Technical Bulletin 00204

Customer Notifications/Tech Tips

Product: DBV-200 units

TOP SENSORS

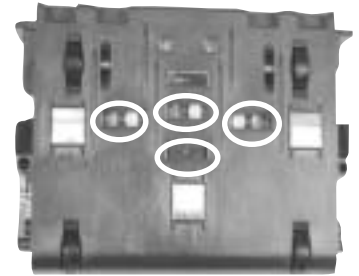
Issue: During the manufacturing process, the DBV-200 units' optical lenses are compression-fitted in place. It is possible for the lenses to be displaced during cleaning or clearing a bill jam. This displacement would cause the following condition:

Error conditions 7 and 14 will increase because the lens functions as a prism. As the sensor light passes through the lens, it is partially refracted, causing improper passage.

Resolution: The lenses can be pushed back into proper positions by disassembling the DBV-200 head and resetting the lenses. The procedure will take approximately 3 minutes for the top shelf lenses, and approximately 10 minutes for the bottom shelf lenses.
